13 - BODY

Glove boxes — all 505 models

Part Number 8222.33	Part Number 8222.34

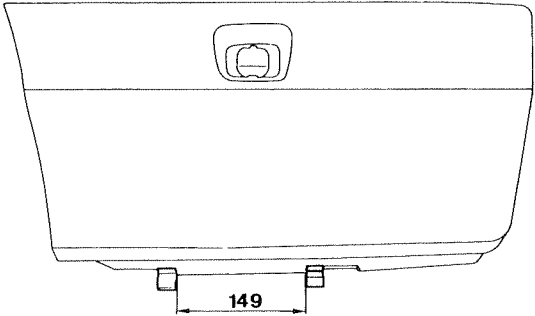
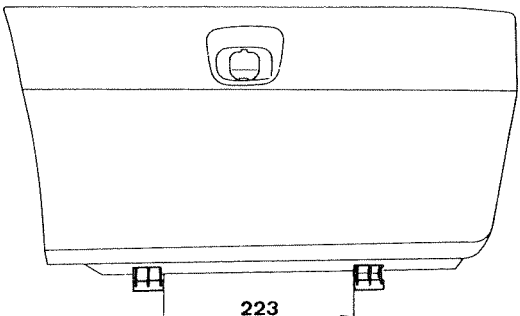
When stocks of glove boxes as fitted to 505 → MY81 are exhausted, the Parts Division will supply instead a glove box as fitted on 505 → MY82.

To fit the latter, it is necessary to use a glove box bracket (Part Number **8222.34**) with a different lower fixing (1) from the earlier bracket (Part Number **8222.33**).
